Parts ID Database Testing

Hajime Muramatsu

Parts ID

- Must have a PartsID for every entry in the HWDB.
- PartsID DB;
 - ▶ generates such ID,
 - ▶ makes sure it is unique (has not been employed)
- George Salukvadze has developed such DB and its test version is accessible @;
<https://dune-pbs-id-gen.web.cern.ch/dune-pbs-id-gen/index.php>
- Rest of this talk is a report of my experience from the web site.
The web site provides a GUI-based access.

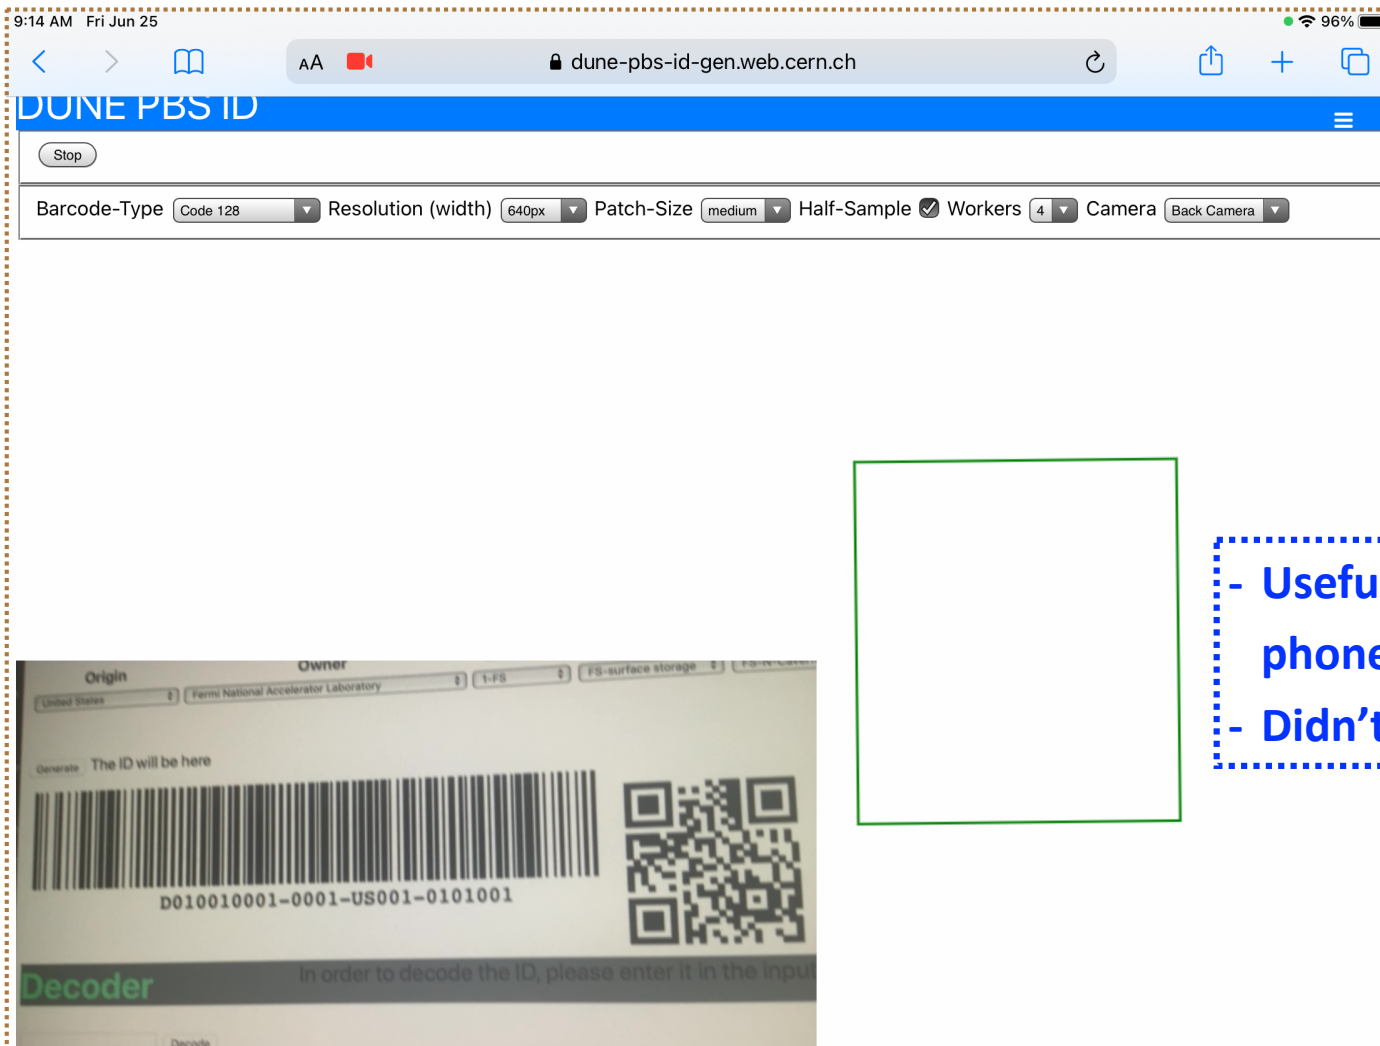
Barcode Scanner

- Useful feature, especially with your phone/iPad.
- Didn't work well with my iPad camera.
